## **Proposal for amendments to ECE/TRANS/WP29/GRSG/2010/22 - Regulation No. 46 (Devices for indirect vision)**

OICA welcomes the document GRSG/2010/22 proposed by the GRSG informal group on Camera/monitor systems, and generally supports the introduction of provisions for those systems into UNECE R46.

Figure 7:  
Class IV ~~wide-angle~~ field of vision

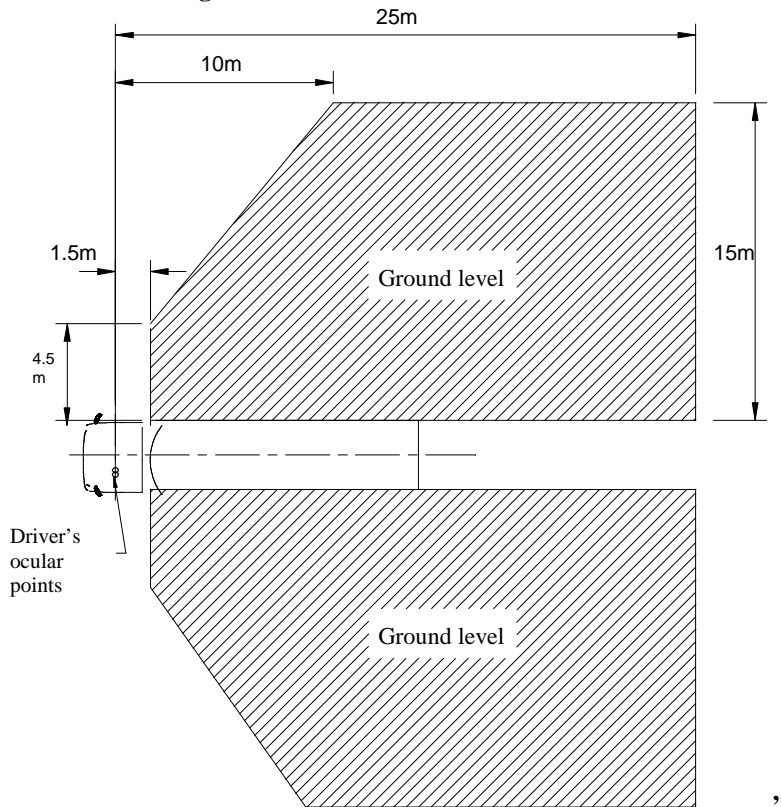
*Paragraphs 15.2.4.4 to 15.2.4.4., amend to read:*

- “15.2.4.4. ~~Wide-angle view device~~ **Class IV field of vision**
- 15.2.4.4.1. ~~Wide-angle~~ field of vision on the driver’s side  
The field of vision ...driver’s ocular points (see Figure 7).
- 15.2.4.4.2. ~~“Wide-angle”~~ field of vision on the passenger’s side  
The field of vision ... driver’s ocular points (see Figure 7).
